## FIELD SERVICE BULLETIN

FSB Number: **LACCFSB2006-315**  
Author: João Sousa  
Date: Jul 17<sup>th</sup>, 2006  
Total No. of Pages: 4  
Subject: **GSM V3 Black – Battery door color mismatch**  
Model Affected: GSM V3 Black  
Level of Repair: 2

Color mismatch  
between battery  
door and phone  
housing.

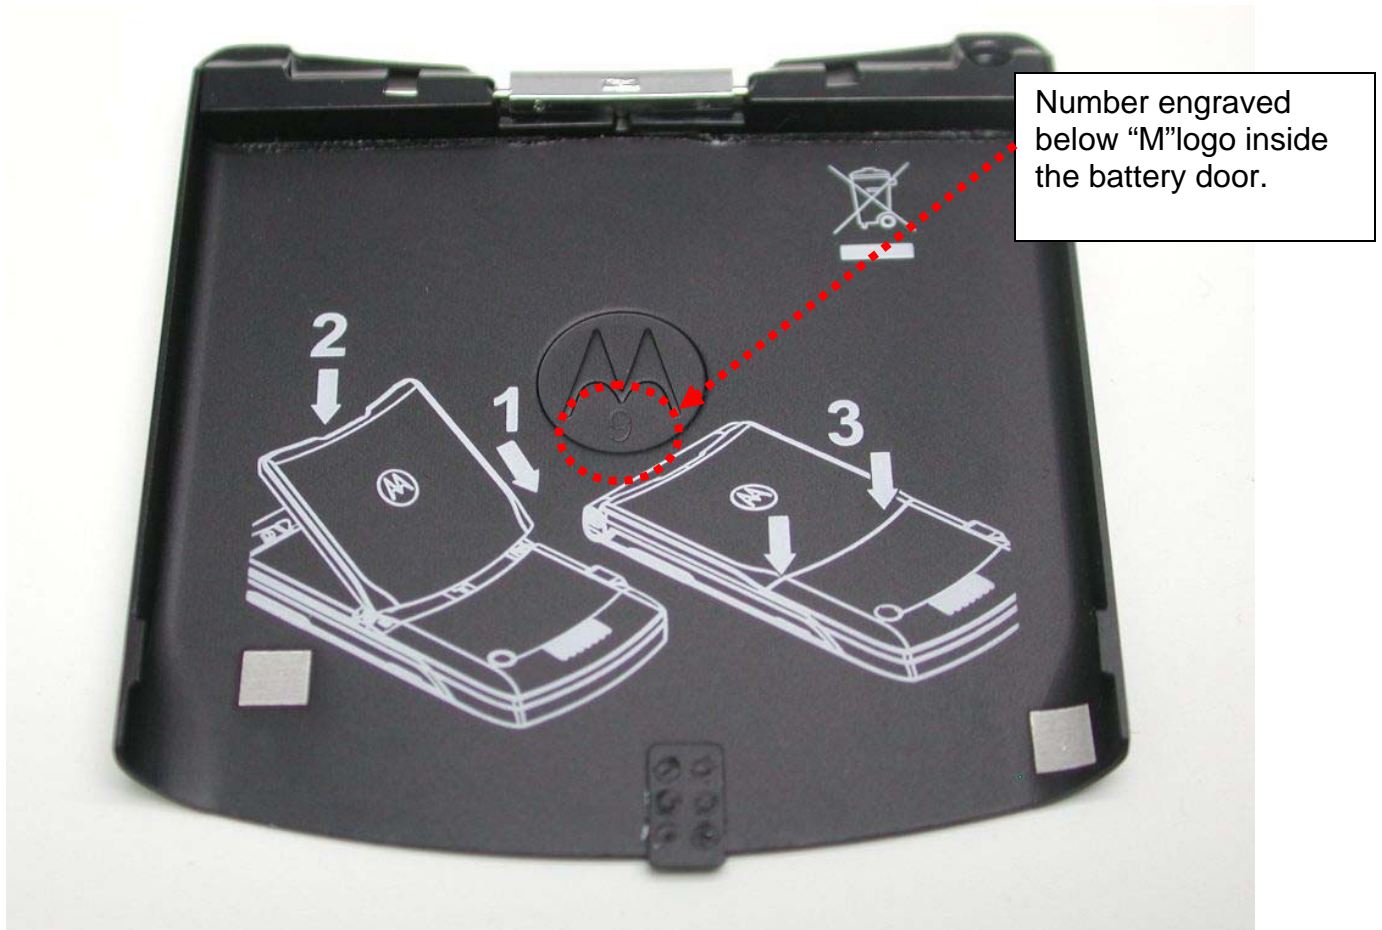
Service is aware that some GSM V3 phones have been returned with customer complaints related to battery door - color mismatch. The failure mode analysis revealed that Foxconn battery doors are out of color specification limits, thus causing customer to notice a color difference between battery door and phone back housing. See pictures below for details :

The solution is to replace customer battery door (PN SHN8962A) by a new one.

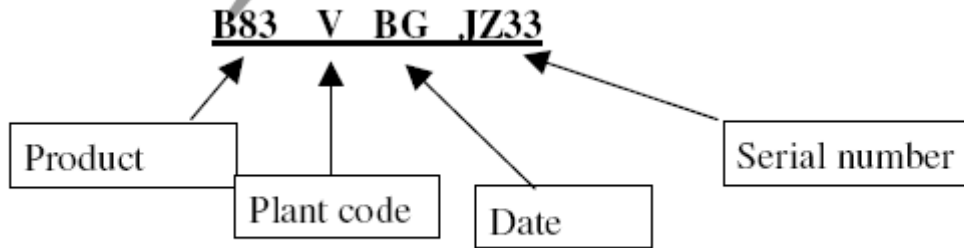
1. Verify if customer battery door is from Foxconn, according to below procedure :
  - a) open the battery door.
  - b) Look the inner side for the “M” logo.
  - c) Foxconn battery door has a number engraved below the “M” logo. See picture below for details :

3. If battery door is from Foxconn and month of manufacturing of phone is older than July-2006, then proceed battery door replacement.
